# **REVISED ANALYSIS OF BROWNFIELD CLEANUP ALTERNATIVES**

Former Frontier Leather Tannery Property  
1210 SW Oregon Street  
Sherwood, Oregon  
Cooperative Agreement BF-00J93201

Response to Comments Table: Draft Analysis of Brownfield Alternatives  
(dated October 5, 2017)

Comment letter from DEQ regarding: Analysis of Brownfield Cleanup Alternatives (Draft),  
dated October 24, 2017

SELECTED REMEDIAL ALTERNATIVE MAP  
REVISED

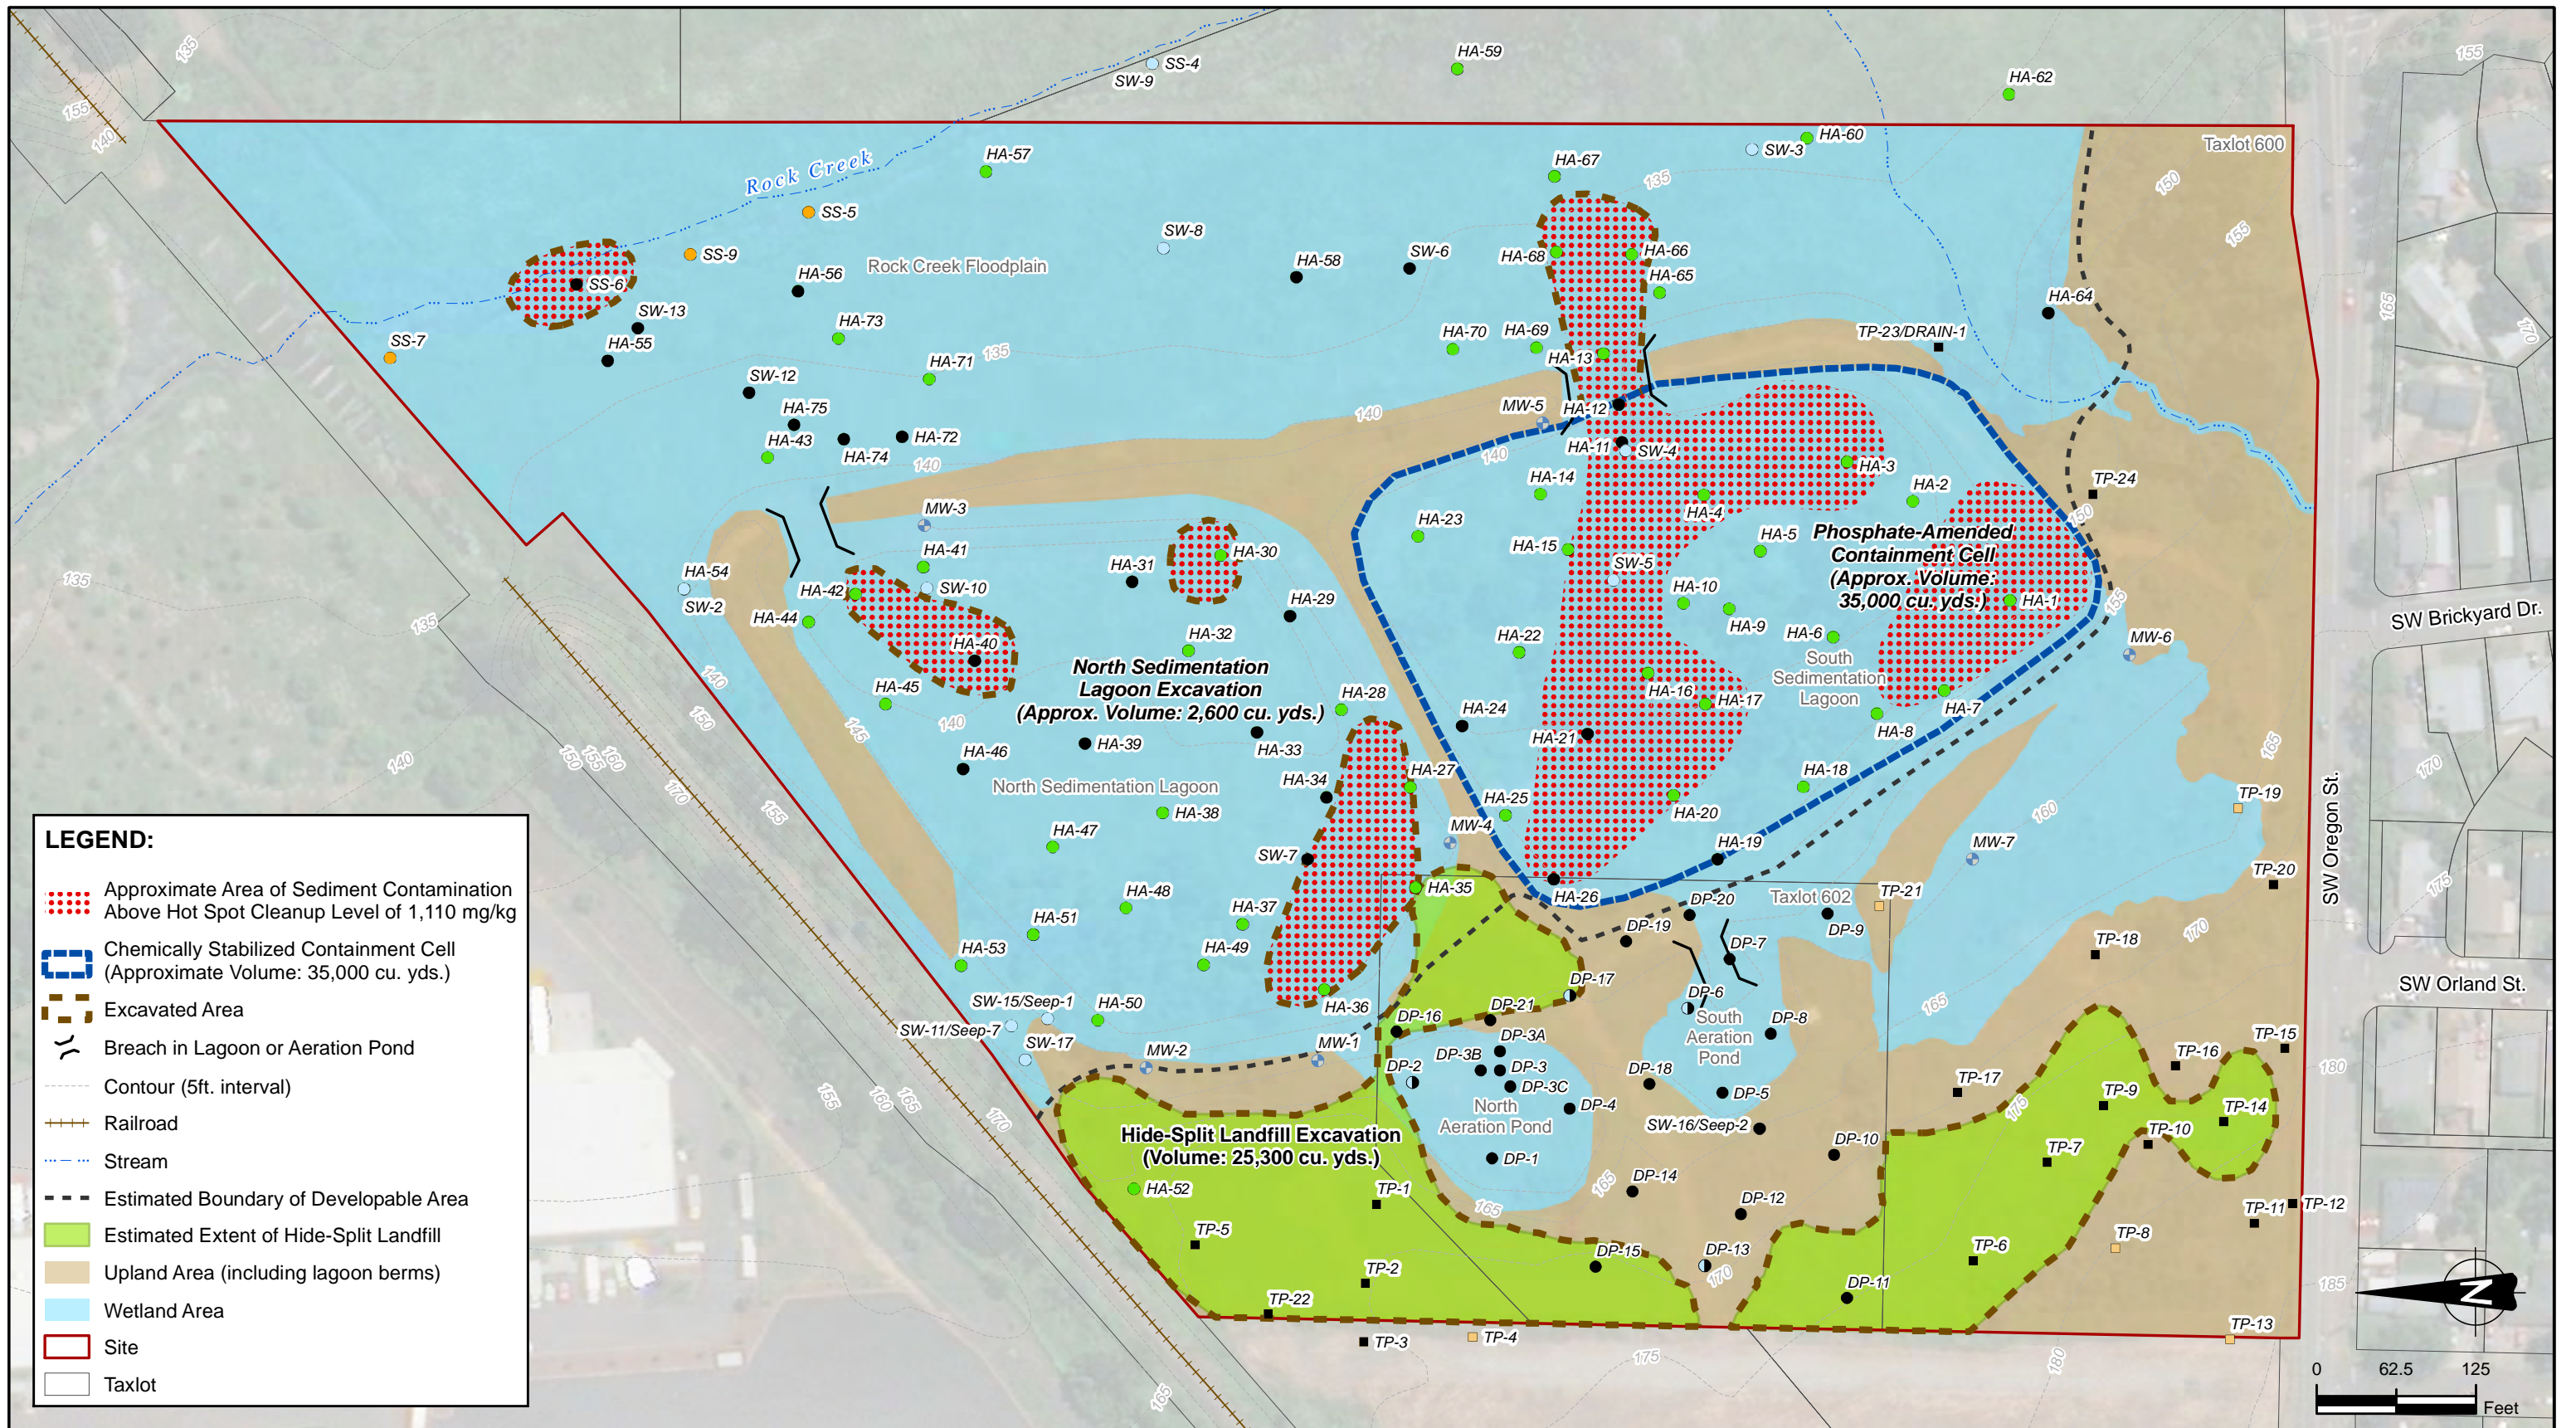
Under preferred remedial Alternative #4, the northern sedimentation lagoon and upland hide removal area apparently would not be capped. Because there will be residual contamination above ecological RBCs (but below HS levels based on 10 times the applicable RBC) in the northern sedimentation lagoon and the Rock Creek floodplain east of the sedimentation lagoons, there should be a discussion of residual contamination, including leave surfaces of excavated areas, and also residual risk to benthic and terrestrial receptors. For the upland area that is likely to be developed consistent with current zoning, DEQ will not require a residual risk assessment. DEQ made a similar determination with regard to ecological risk for upland areas at the Ken Foster Farm Site that are reasonably likely to be developed for residential use.

In their comment letter, the DEQ requested evaluation of the protectiveness of the selected remedy presented in the ABCA (comment 9.10), to determine if residual contamination that will be left in place after remedy implementation has the potential to present unacceptable risk to terrestrial and benthic receptors. This memorandum presents that evaluation and its outcome for DEQ consideration in advance of revising and resubmitting the ABCA. The remainder of the DEQ comments not related to the protectiveness evaluation will be addressed in the revised ABCA.

The protectiveness evaluation identified two key outcomes. First, the preliminary evaluation of Remedy Scenarios 1 and 2 determined that the remedy would not be protective enough for terrestrial ecological receptors unless the excavation area was modified because the average chromium concentration used as the surrogate confirmation sample concentration was too high. Specifically, the chromium concentrations from samples HA-66 (890 mg/kg) and HA-68 (260 mg/kg) contributed to an average concentration of 109.9 mg/kg, which in turn led to 90% UCLs that were greater than the sediment cleanup level of 111 mg/kg. Therefore, a modification of the selected remedy is required to expand the excavation area at the south sedimentation lagoon to include soil represented by samples HA-66 and HA-68. This modification would expand the excavation footprint by an estimated 8,052 square feet at a depth of 1.5 feet below ground surface, and is illustrated on Figure 4. The estimated increase in excavated soil was therefore calculated at 447 cubic yards. This estimated increase in excavated volume will be included in the revised alternatives analysis for all remedial alternatives presented in the ABCA.

The protectiveness evaluation was refined using the modified excavation area (which excludes HA-66 and HA-68 from the existing Site data set), and using the refined surrogate confirmation sample concentration of 97.5 mg/kg. The refined 90% UCL calculated for each remedy scenario is presented in Table 1, along with the selected cleanup levels. ProUCL output is presented in Attachment B.

Therefore, the selected remedy that incorporates the expanded excavation area to remove soil from samples locations HA-66 and HA-68 is considered protective.
